RYKER 2025 Unit Inspection Required - 143625

Article Detail

Inspection Procedure:

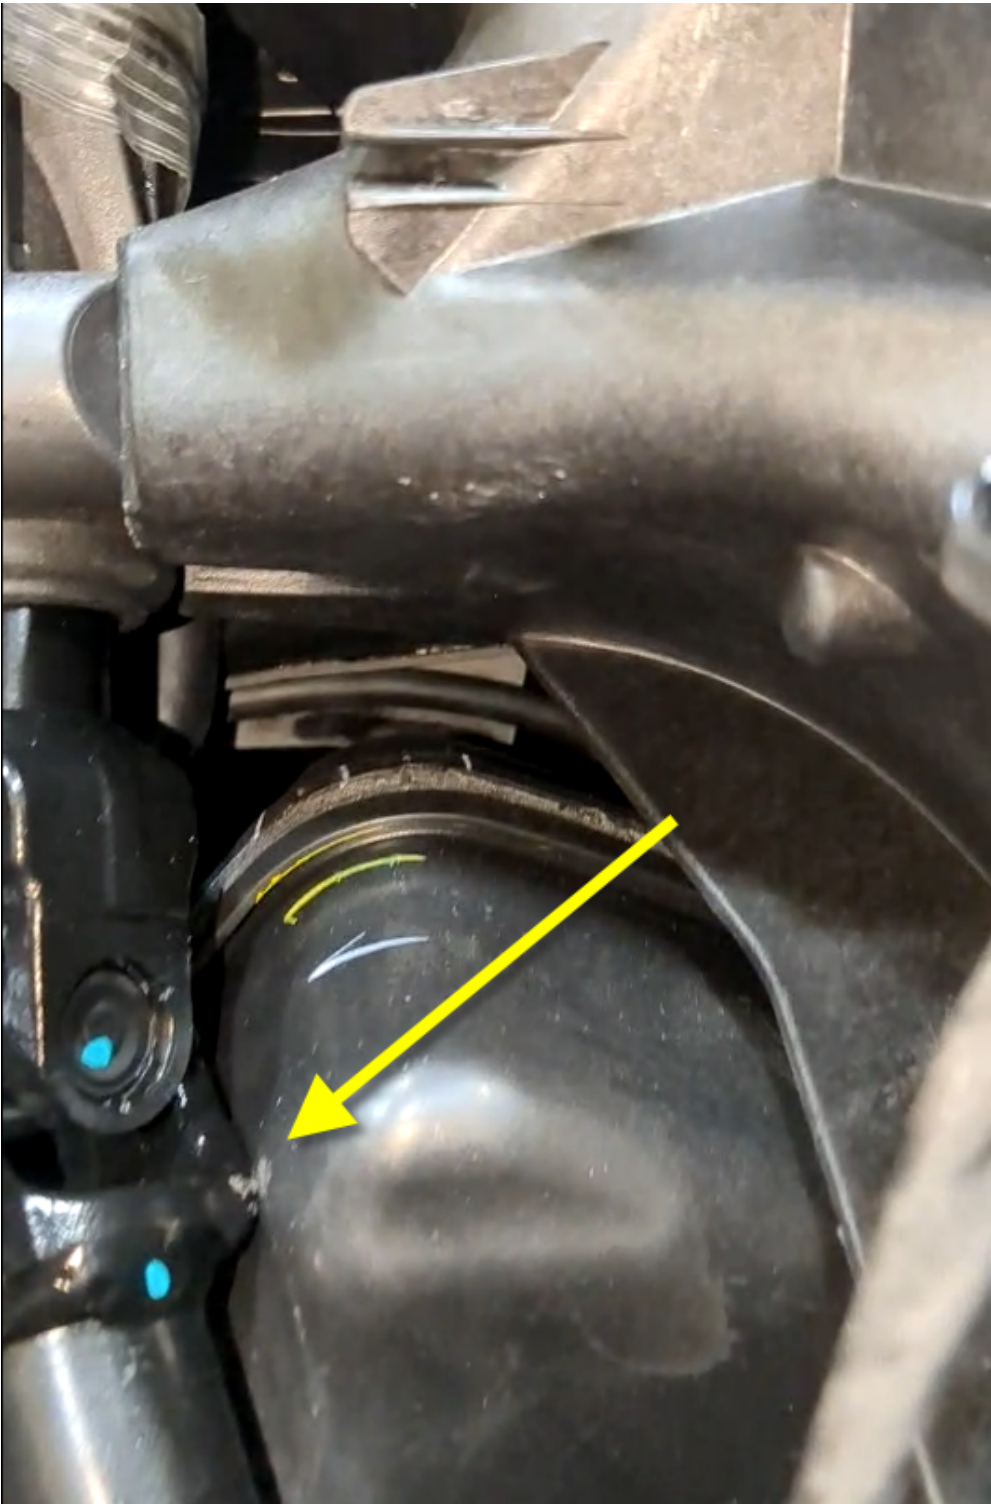
The fuel tank upper rubber pad might not have been installed properly. Also, the steering column might be in contact with the airbox.

Please refer to the attached PDF for the fuel tank inspection.

For the steering column, add 2 shims (707002397) under RH ENGINE supports. *Note that don't install more than 2 shims under RH support because of possible contacts on other parts above the engine.
